Delegated Report		Analysis sheet		Expiry Date:	08/03/2019
		N/A / attached		Consultation Expiry Date:	10/03/2019
Officer			Application Number(s)		
Sofie Fieldsend			2019/0158/P		
Application Address			Drawing Numbers		
190 Goldhurst Terrace London NW6 3HN			Refer to Draft Decision Notice		
PO 3/4	Area Team Signature	C&UD	Authorised Officer Signature		
Proposal(s)					
Excavation of a basement to create a two bedroom flat.					
Recommendation(s):		Refuse planning permission			
Application Type:		Full Planning Permission

The application site is a three storey, plus semi-basement level, mid-terrace house on the North side of Goldhurst Terrace which is located in the South Hampstead Conservation area.

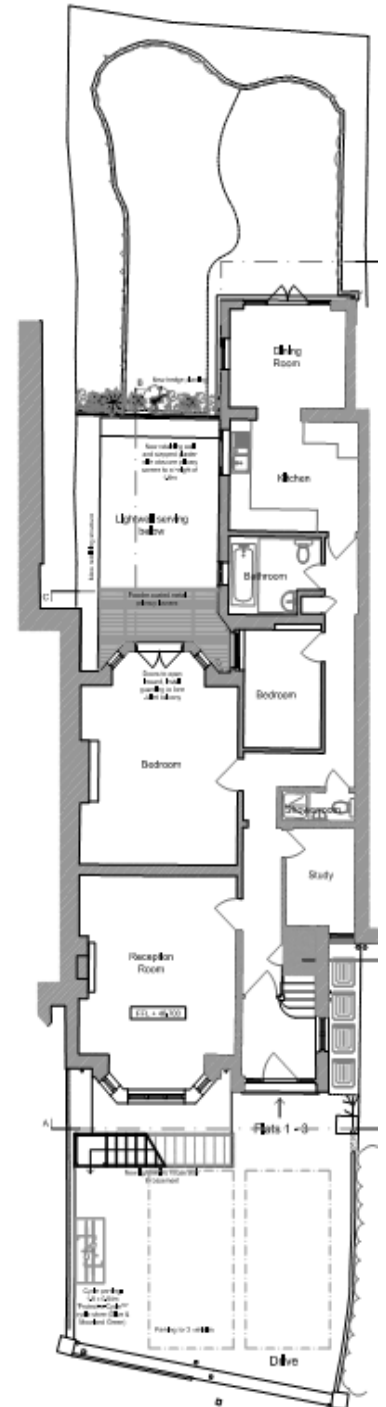
2.1 During the previous application ref. 2016/2689/P, revisions were negotiated to remove the external staircase (separate access), railings, reduce the depth of the front lightwell and include a rear escape ladder in the garden. The ground floor plan of the originally proposed and granted scheme of 2016/2689/P and the current proposal of this application are shown below.

4.3 The proposed flat is now proposed to have its own separate entrance at basement level accessed through the front light well rather than accessed via a communal entrance ground floor level and internal staircase as previously granted. This is no longer considered to be akin to the arrangement in a duplex arrangement where, in the event of a flood occurrence, occupants can exit the lower level to the ground floor level and still be within the main building. The proposal also has removed an escape ladder granted in the previous application that was included to access ground level so there is no longer a secondary means of escape. It is considered in this instance that the proposals for a self-contained unit at basement level is unacceptable and contrary to policies CC3 and A5.

5.6 Concerns were raised about the front lightwell creating a new separate access to the basement flat in the previously approved application ref. 2016/2689/P as well, although amendments were received in that application reducing down the scale of the lightwell and removing the external staircase. The entrance was relocated to within the existing communal entrance at ground floor. In this current application the applicant does not wish to make these revisions again. Therefore it is considered that the scale of the front lightwell appears dominant and inclusion of the separate entrance staircase makes it appear overbearing and does not respect the design of this row of terrace houses.
